CITY OF CODY  
PLANNING, ZONING AND ADJUSTMENT BOARD  
TUESDAY, OCTOBER 13, 2015  
CITY HALL COUNCIL CHAMBERS @ 12:00 NOON

**CITY OF CODY  
PLANNING, ZONING AND ADJUSTMENT BOARD  
STAFF REPORT**

<b>MEETING DATE:</b>	OCTOBER 13, 2015	<b>TYPE OF ACTION NEEDED</b>	
<b>AGENDA ITEM:</b>		P&Z BOARD APPROVAL:	X
<b>SUBJECT:</b>	SITE PLAN REVIEW: DINING PAVILION AT THE BUFFALO BILL CENTER OF THE WEST. FILE: SPR 2015-	RECOMMENDATION TO COUNCIL:	
<b>PREPARED BY:</b>	TODD STOWELL, CITY PLANNER	DISCUSSION ONLY:

SHEET #  
**A1.0**  
**MAIN FLOOR**  
SCALE: AS NOTED  
DATE: 09-30-2015  
REVISED ( 0 )

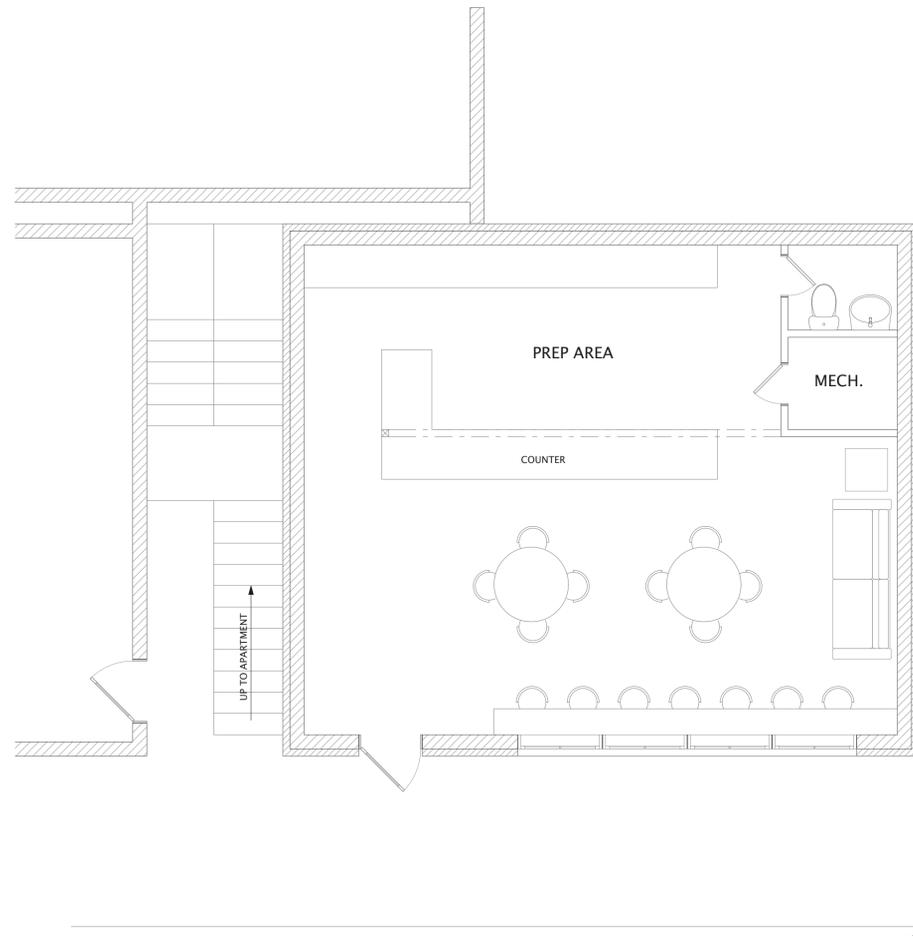
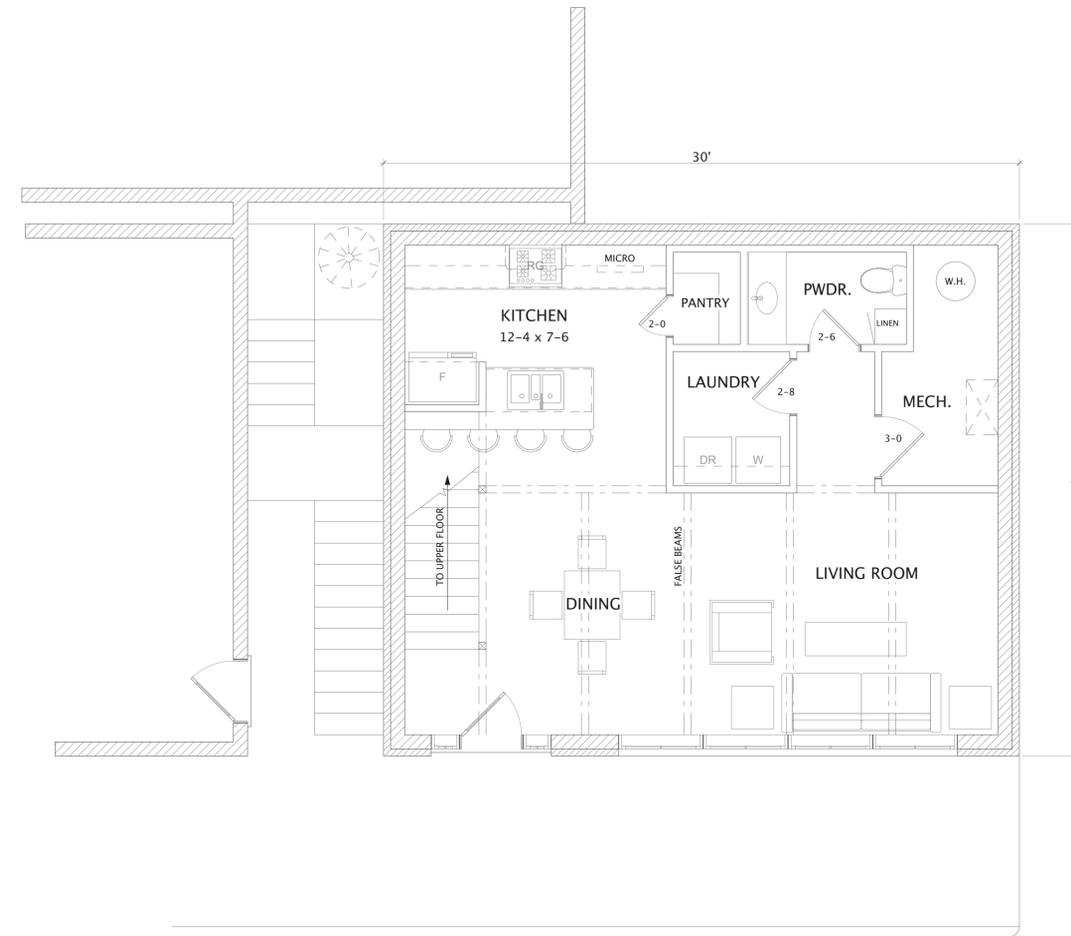
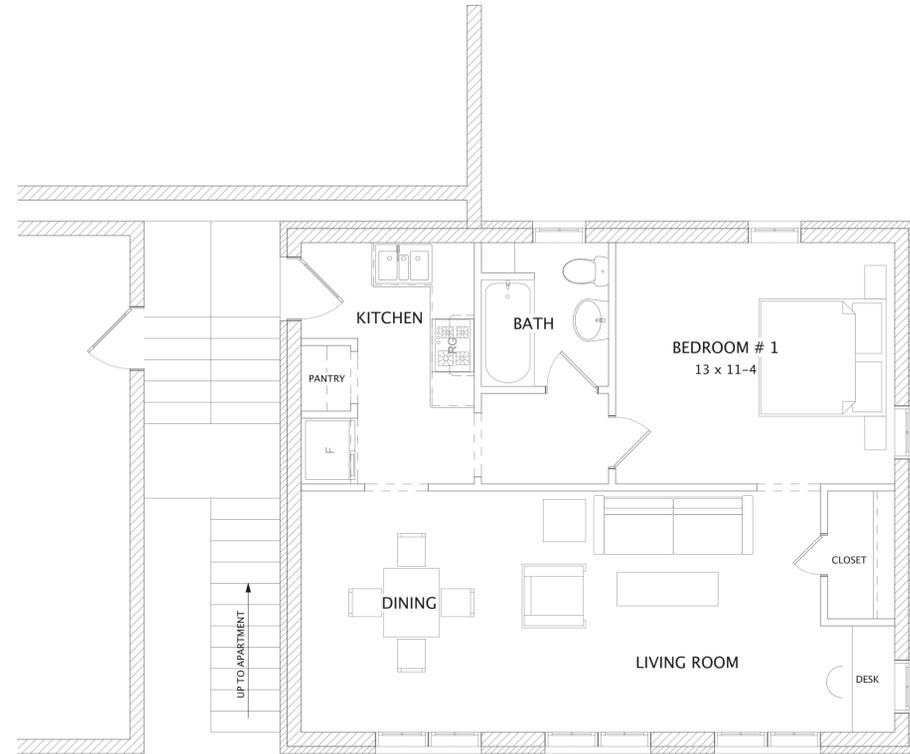
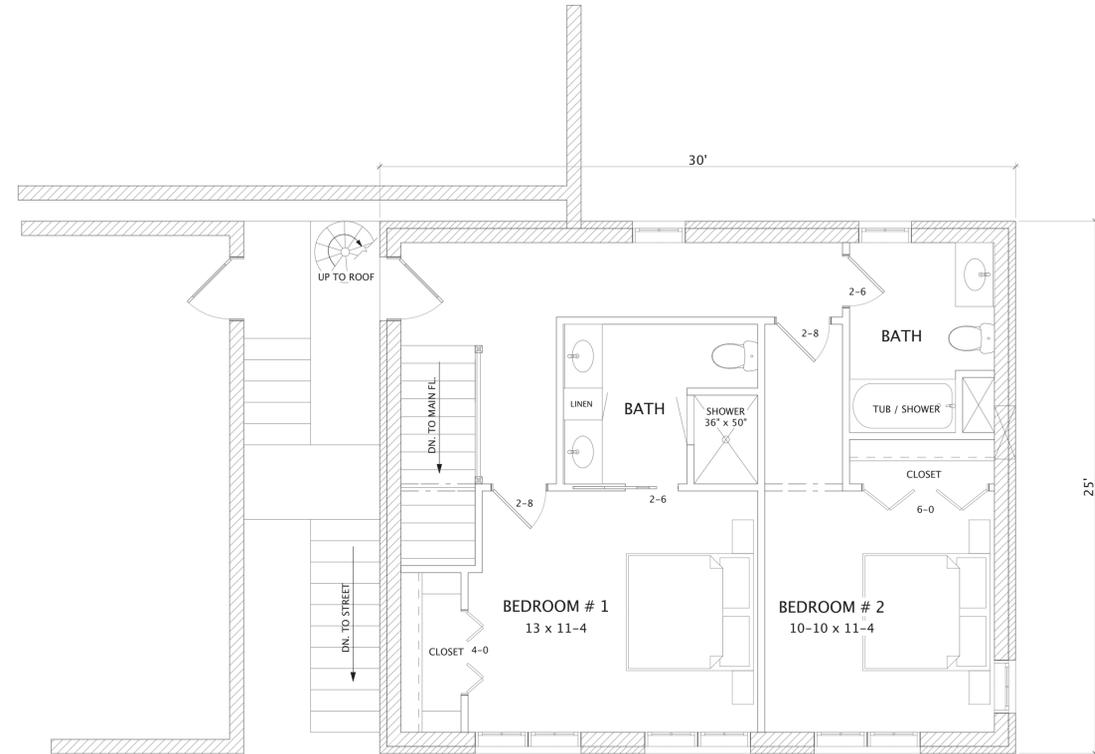
The new windows will be the same size and the existing window opening on the main floor, but taller in height on the second floor. The windows will have a black or bronze casing. A new doorway will replace the commercial glass door.

Subject to the improvements being acceptable to the Board, approve the project as proposed, with the applicant's understanding that the awning sign must be removed to the point that no evidence of it remains, and that the property owner will need to further coordinate with the City and other property owner(s) to meet the building and electrical code standards. A building permit is needed.
